Code Compliance Certificate

030533

3 JOHNSON AVE, AMBERLEY 1726/3

SITE INSPECTION REPORT

Drainage layout for Purvis house
3 Johnson Ave Amberley
Consent No 030533

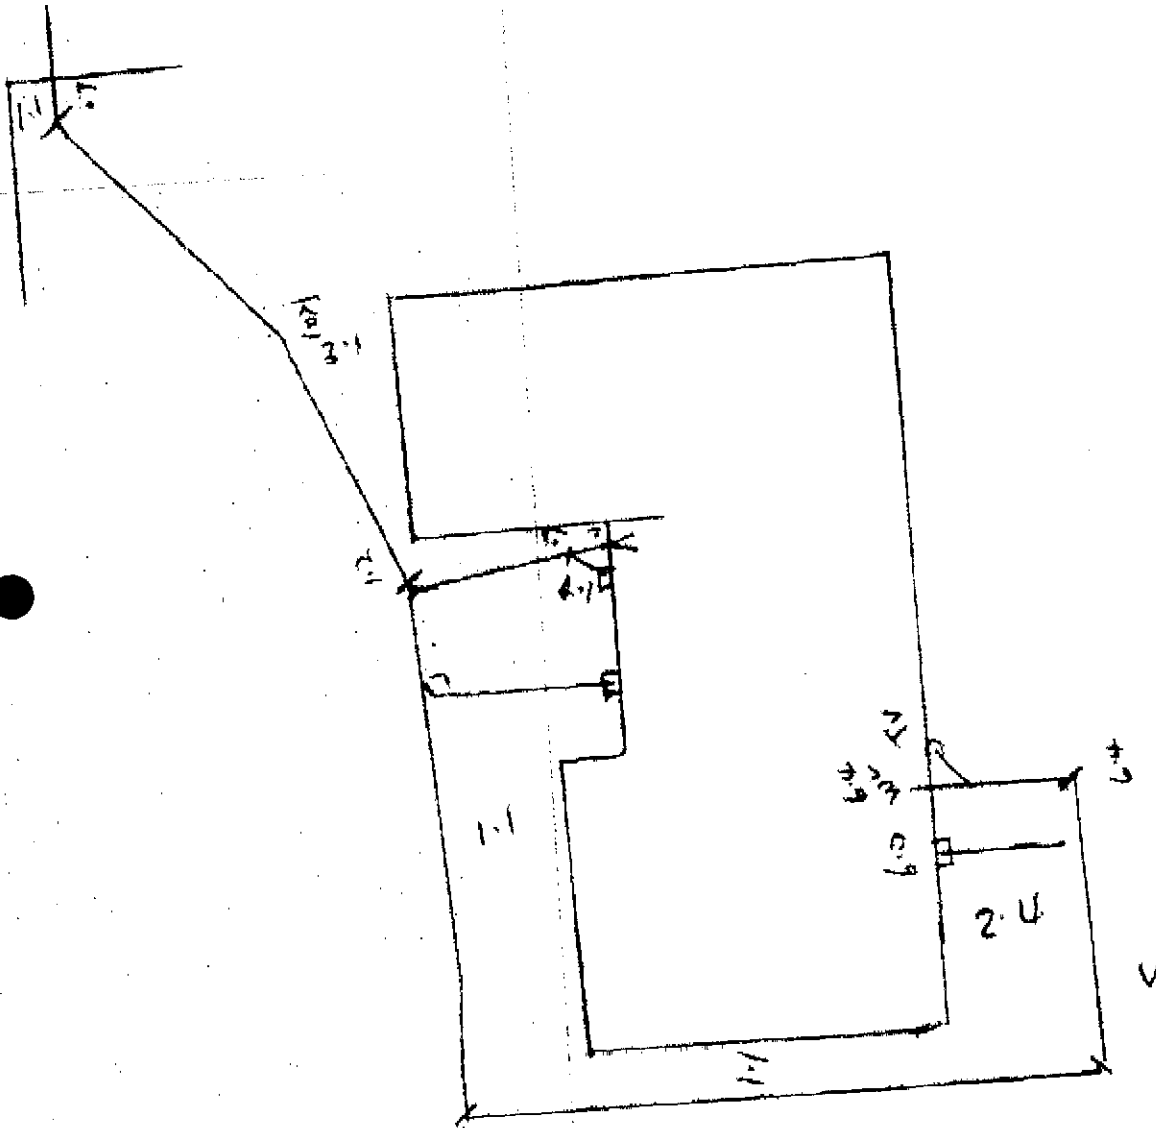
*Exterior:- Remaining works to complete. Fit grates to all downpipes, seal behind Gully dish outside main bathroom. Seal above meter box. Forward Plumbers Pressure Test Declaration plus As laid Drainage plan.

6/9/2004, All of above requests have now been fulfilled.
